# UNITED STATES PATENT AND TRADEMARK OFFICE

APPLICATION NO.	FILING DATE	FIRST NAMED INVENTOR	ATTORNEY DOCKET NO.	CONFIRMATION NO.
10/534,835	05/13/2005	Hidenobu Hamada	2005-0795A	6722

## Office Action Summary

## **DETAILED ACTION**

wherein the exiting beam is made to exit from the optical transmission line, and the output signal corresponding to the exiting beam is outputted (column 34, lines 6-11). Figure 29 of the '159 patent is reproduced below.

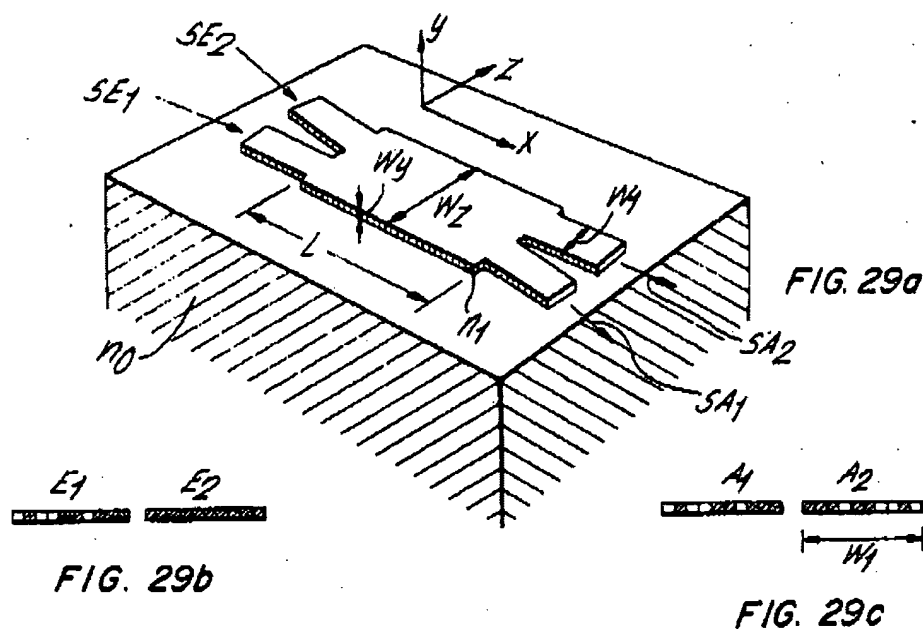
*In re* claim 1, the '159 patent shows in Figure 29 an optical device that connects, by a signal beam, between an externally inputted input signal and an output signal to be outputted (column 33, lines 14-31), the optical device comprising:

an optical transmission line being sheet-form and including a refractive index distribution such that a highest refractive index part is provided in a direction of a thickness of the sheet and a refractive index does not increase with distance from the highest refractive index part in the direction of the thickness (column 33, lines 21-32),

wherein a signal beam corresponding to the input signal is made incident on the optical transmission line as an incident beam (column 33, lines 44-52),

wherein inside the optical transmission line, the incident beam is transmitted, in a direction of a length that is orthogonal to the direction of the thickness, in multiple modes having a plurality of eigenmodes in a direction of a width that is orthogonal to both the direction of the length and the direction of the thickness, and an exiting beam is generated by the plurality of eigenmodes interfering with each other in the direction of the length (column 22, lines 28-56), and

*In re* claim 14, the device shown in Fig. 29 of the '159 patent operates as a 1 x 2 splitting device and includes:

an incident surface  $SE_1$  for making the incident beam incident;  
an exit surface  $SA_1/SA_2$  for making the exiting beam exit, and  
the size in the direction of the length is inherently a value that satisfies the claimed expression because the transmission line of the '159 patent has the same physical structure and operates in the same manner to that claimed.
